NZ 60/06 INDONESIA – Sulawesi – Flores Sea – Namboh Laki South-westwards – Depths.

UKHO Notice 1068/06
 NI 46/2006

Chart NZ 14052 (INT 52) [55/06]

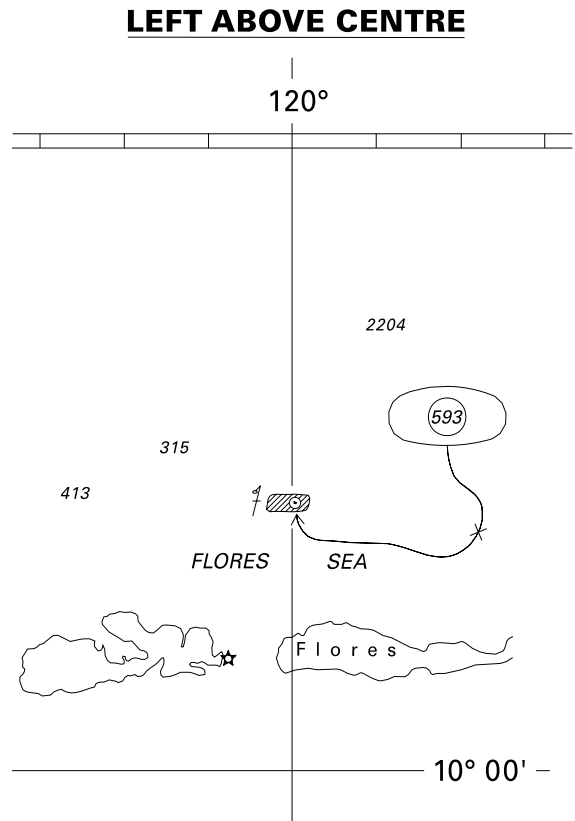
Insert depth 593 enclosed by 1000m contour

6° 49'.5S., 120° 01'.7E.

Chart NZ 14060 (INT 60) [251/05]

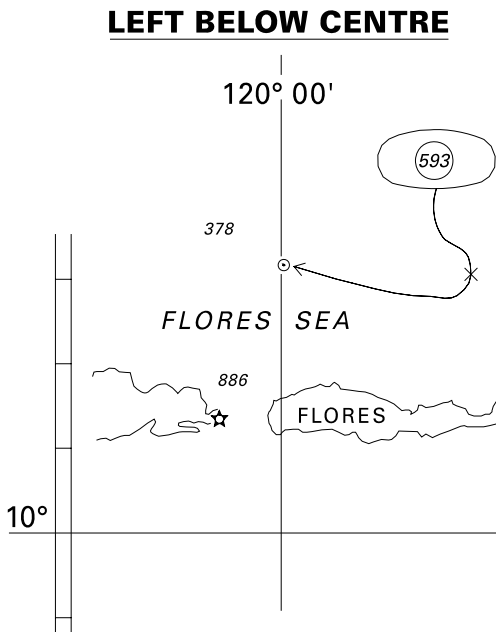
Insert depth 593 enclosed by 1000m contour

(a) 6° 49'.5S., 120° 01'.7E.

Delete depth 1302, adjacent to

(a) above
